Form 3160-5 (June 2019)		UNITED STATE PARTMENT OF THE I EAU OF LAND MAN	NTERIOR		ON Expi	DRM APPROVED MB No. 1004-0137 res: October 31, 2021 49IND8464
		NOTICES AND REPO	ORTS ON WELLS		6. If Indian, Allottee or	
Do not	t use this	form for proposals t	o drill or to re-enter an PD) for such proposals		EASTERN NAVAJO	
	SUBMIT IN	TRIPLICATE - Other instru	uctions on page 2		7. If Unit of CA/Agree	ment, Name and/or No.

ENDURING RESOURCES REQUESTS TO PLUG AND ABANDON THE ABOVE MENTIONED WELL. PLUGGING PROCEDURE, WELLBORE DIAGRAM, AND RECLAMATION PLAN ARE ATTACHED.

PLUG AND ABANDONMENT PROCEDURE

CONDITIONS OF APPROVAL

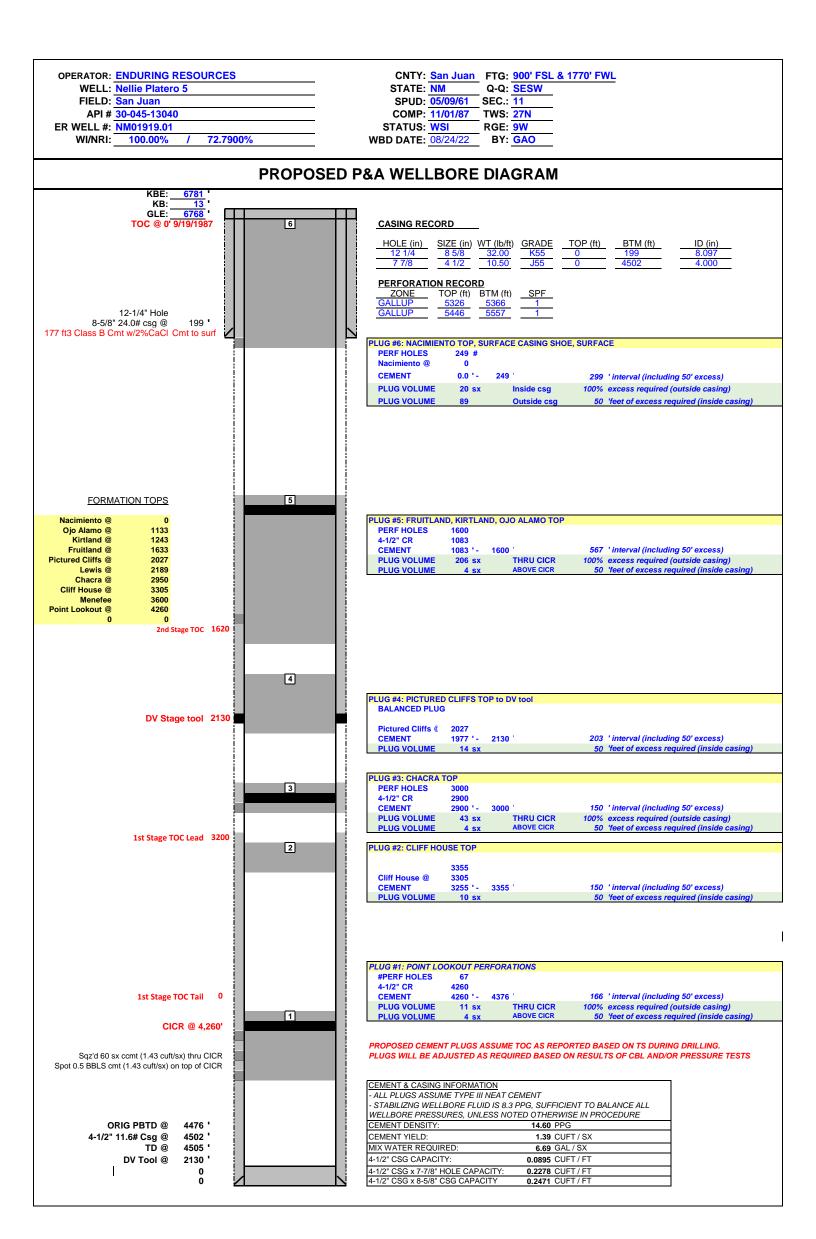
9) PLUG #5: FRUITLAND, KIRT	LAND, OJ	O ALAMO TO	Р	
RU wireline, perforate 4 SP	F @ 1,600	' MD. TIH witl	n 4-1/2" CR o	n 2-3/8" work-string. Sting
out, press test to 500 psi. S	ting in, att	empt to estal	olish cirulatio	n. Pump cement. TOOH.
Perf holes: 1	,600'			
Plug Coverage:	1,083'	to	1,600'	
Cement Volume:	206 sx	below CR	4 sx	above CR
	210 sx	TOTAL

- Bring the bottom of Plug #5 (Fruitland, Kirtland, Ojo Alamo) down to 1683' to cover 50' below the Fruitland formation top (1633').

- 1. Plugging operations authorized are subject to the attached "General Requirements for Permanent Abandonment of Wells on Federal and Indian Lease."
- The following modifications to your plugging program are to be made:
 a. Bring the bottom of Plug #5 (Fruitland, Kirtland, Ojo Alamo) down to 1683' to cover 50' below the Fruitland formation top (1633').
- 3. Farmington Office is to be notified at least 24 hours before the plugging operations commence at (505) 564-7750.
